14TH & REPUBLICAN

DRB RECOMMENDATION MEETING

DPD#3012837 APRIL 17, 2013

REVIEW ITEMS:

View of L4 North Facade Setback [Previous Design]

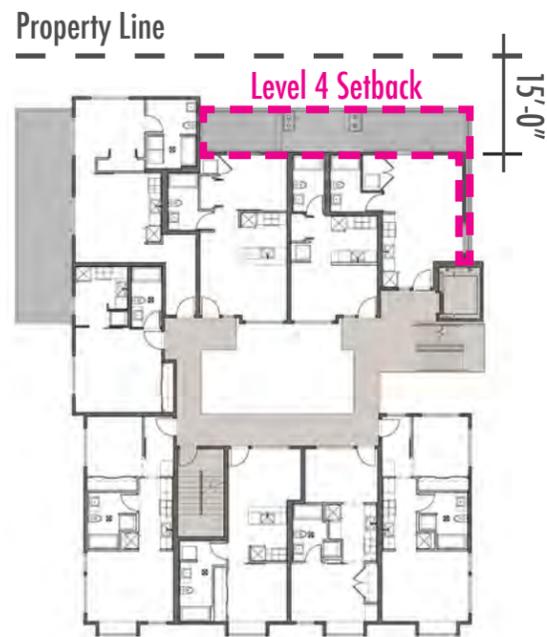
The Board restated its disinclination to approve the facade length departure due to the overscaled massing on the north elevation. The fourth floor should be set back 15 feet from the property line with the fourth floor one continuous wall east of the portion of the third and fourth floors that projects forward of the cedar siding wall.

In spite of modifications to the massing in response to earlier guidance, the revisions to the north elevation remained problematic for the Board. As the massing relates closely to the departure request for greater facade length along the north side, the Board requested increased depth to the upper level (15 feet from the property line) for the (entire) length of the north facade east of the two-story projecting bay before considering a recommendation of approval for the departure.

- 1** Fourth floor north facade set back 15 feet from property line
- 2** Fourth floor east facade set back from the building face

North Facade Departure Sketch

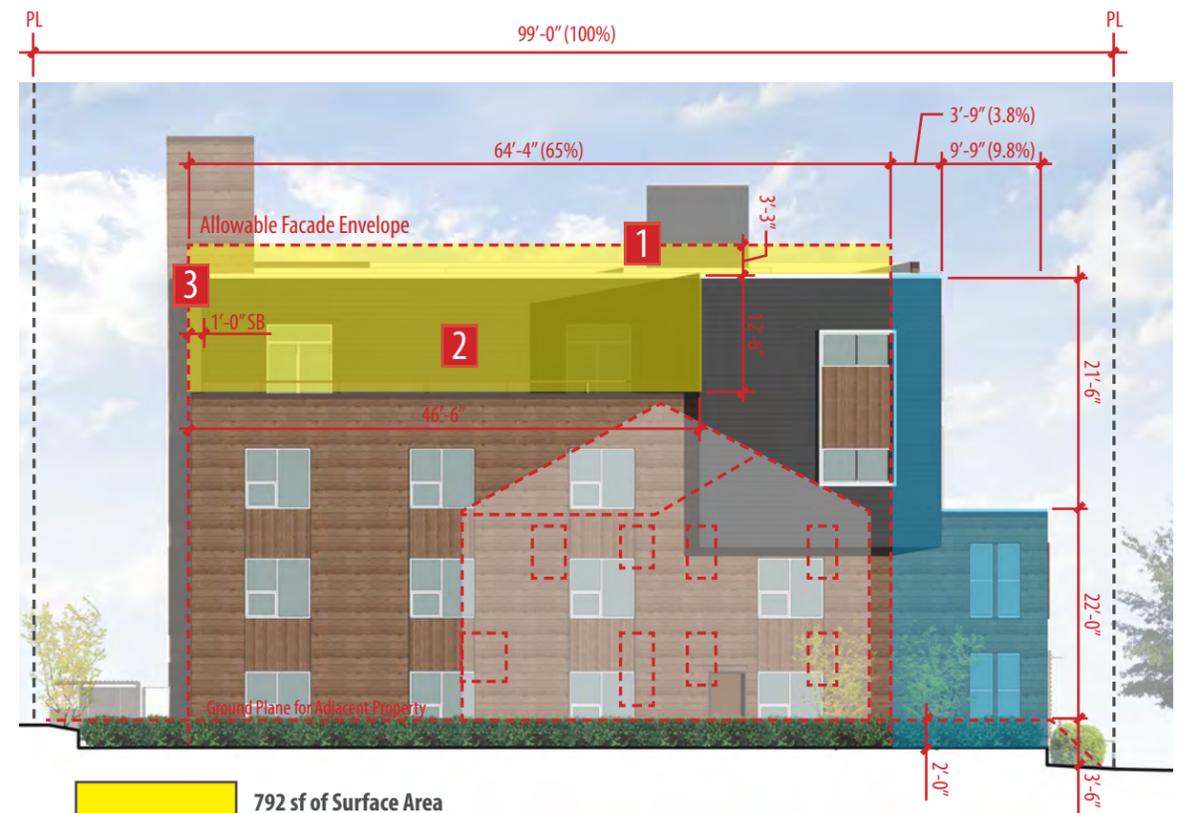
DEPARTURE
SMC 23.45.527.B.1 - Maximum Façade Length Required/Allowed

Requirements:
The maximum façade length of all portions of facades within 15 feet of a lot line that is neither a rear lot line nor a street or alley lot line shall not exceed 65 percent of the length of that lot line.

Proposed:
An additional 13'-6" of façade length on the north interior lot line for a façade length of 78.6% of the total lot line length.

- 1** Building height has been held down 3-3" below maximum allowable building height.
- 2** 67% of 4th Floor along North facade has been set back 15'-0" from property line.
- 3** The East facade of the 4th Floor (26 LF), North of the elevator core, has been set back 1'-0" to create a plane shift where materials intersect.

Proposed Configuration

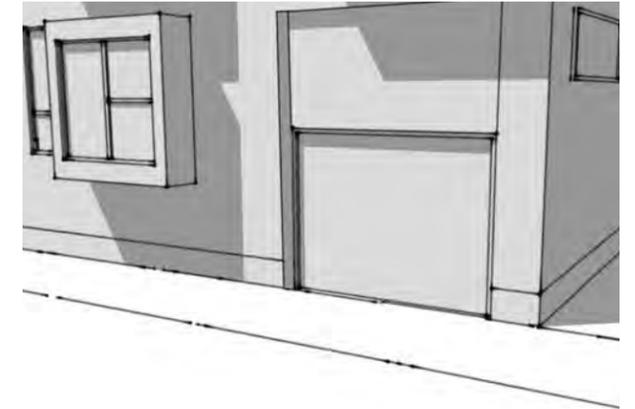
The Board found the position and the design of the garage door problematic as it lacked a strong kinship to the south facade. The Board recommended that the applicant raise the height of the door, align the door with the bay windows above it, and provide an architectural element that relates to the physical form of the bays or overall elevation. Simply, the garage door should appear better integrated with the larger elevation.

SMC 23.45.536.D.3.b - Screening of Parking by Garage Doors

Garage doors facing the street shall be set back at least 15 feet from the street lot line, and shall be no closer to the street lot line than the street-facing façade of the structure.

- 1** Garage door has been recessed 12" from south building facade
- 2** Garage recess has been raised to align with top of adjacent bay window, thereby increasing the apparent height of the door
- 3** Garage door is aligned with east edge of bay windows above

RAILING SYSTEM

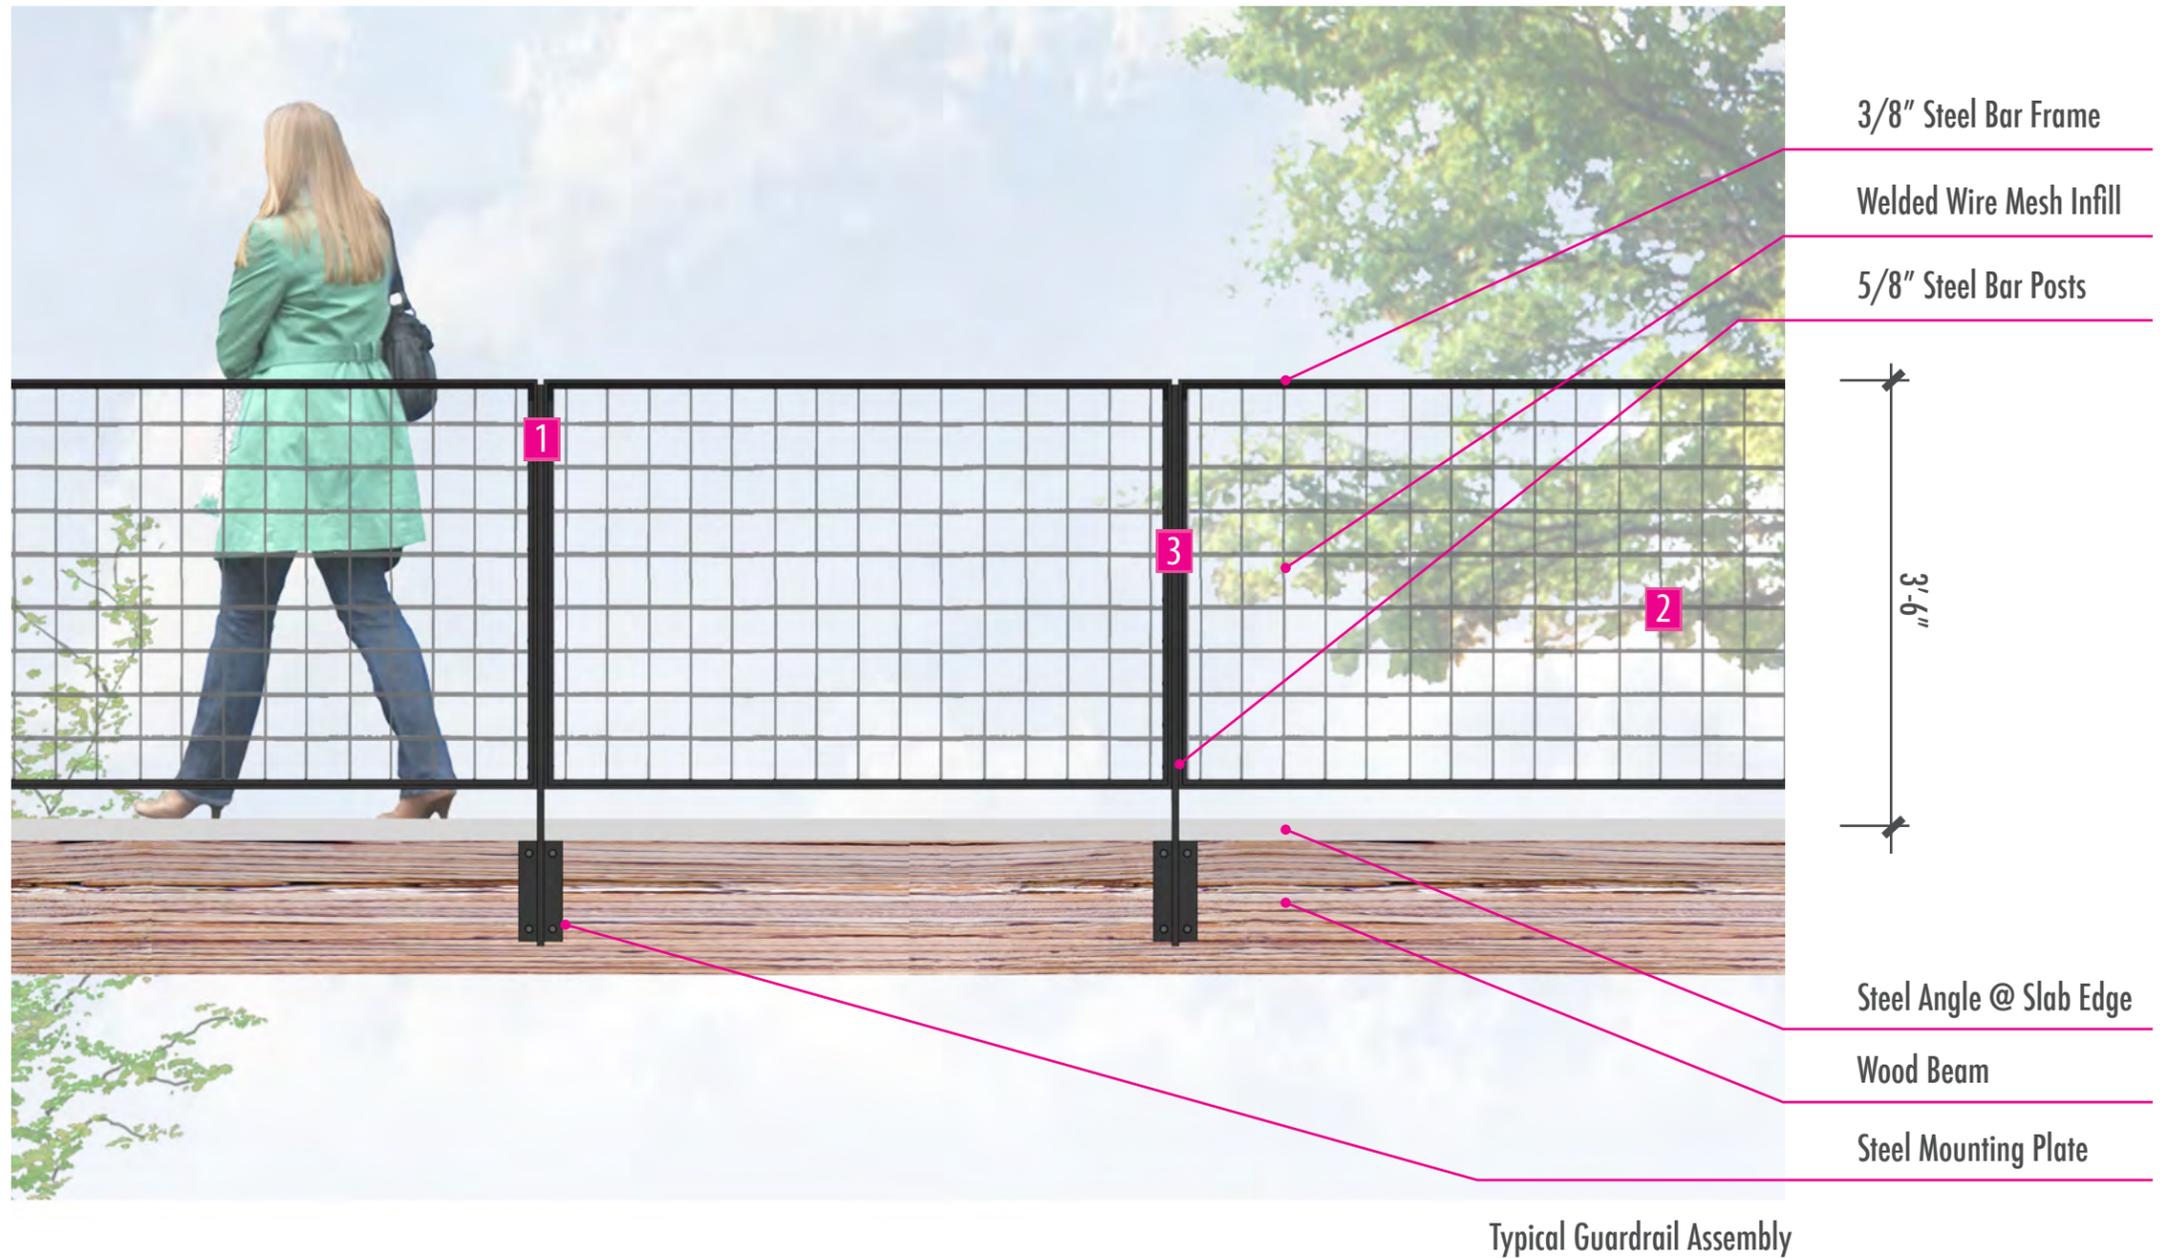
By the February Recommendation meeting, the applicant had reorganized the edges of the courtyard to reduce the amount of stairs and upper level exterior walkways impeding into the court. In spite of these efforts, the Board requested that the applicant continue to reduce the visual clutter created by the materials comprising the railings and walkways. The busyness of the selected materials obstructs the important view created through the courtyard. Staff note: Consider using glass railings, a more planar underside of the walkways, and potentially fewer posts.

- 1** Wider spacing of support posts, thereby reducing number of posts
- 2** Thinner wire mesh infill with larger opening size creates higher level of transparency
- 3** Replaced steel tube posts with steel bar to provide a thinner profile

FIG 01: North Facade Departure Sketch

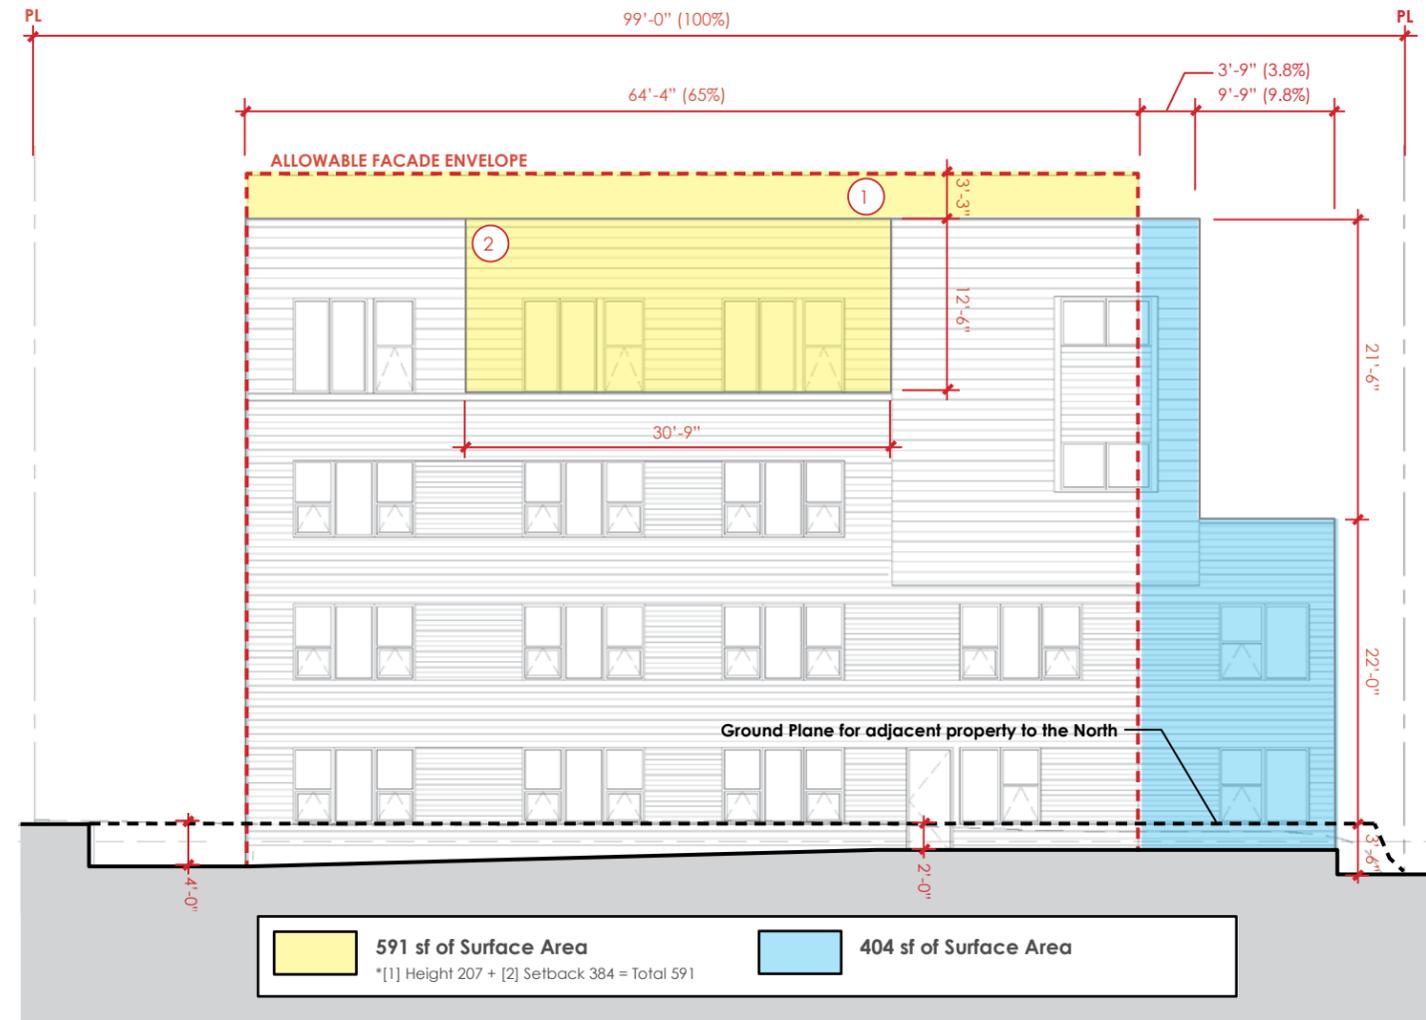
EDG Recommendations: Noting the length and height of the north façade's impact upon the neighbors, the Board expressed its disinclination to grant the departure request related to this façade. Reconsideration of the departure would require greater setbacks and/or significant modification to the height and modulation of the wall. The Board asked for the game court area at the northeast corner to be reconsidered, providing passive landscaping to reduce noise impacts upon the neighbors.(see Guidance E-2)

The maximum façade length of all portions of façades within 15 feet of a lot line that is neither a rear lot line nor a street or alley lot line shall not exceed 65 percent of the length of that lot line.

An additional 13'-6" of façade length on the north interior lot line for a façade length of 78.6% of the total lot line length.

- 1 Building Height has been held down 3'-3" below maximum allowable height.
- 2 45% of 4th Floor along North facade has been set back 11'-0" from property line.

FIG 02: Garage Door Departure Sketch

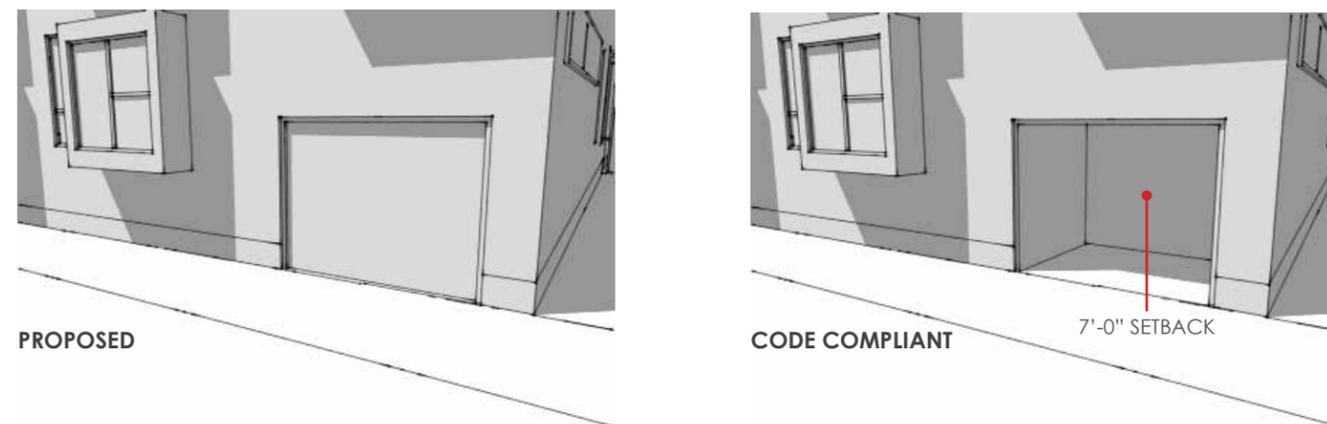
Garage doors facing the street shall be set back at least 15 feet from the street lot line, and shall be no closer to the street lot line than the street-facing façade of the structure.

Place the garage door 7'-5" from the street lot line.

If the project garage door was located per code (SMC 23.45.536.D.3.b Screening of Parking by Garage Doors), it would be set back 7.5' from the face of the building to meet the 15' minimum setback. The proposed departure proposes locating the door along the building face, which is set back 14' from the back of sidewalk. This orientation promotes safety, as it would eliminate a 7.5' additional setback (recess) into the building and is architecturally consistent with adjacent garage access that is typically set flush with the building face. This departure allows the project to better meet the following design guidelines:
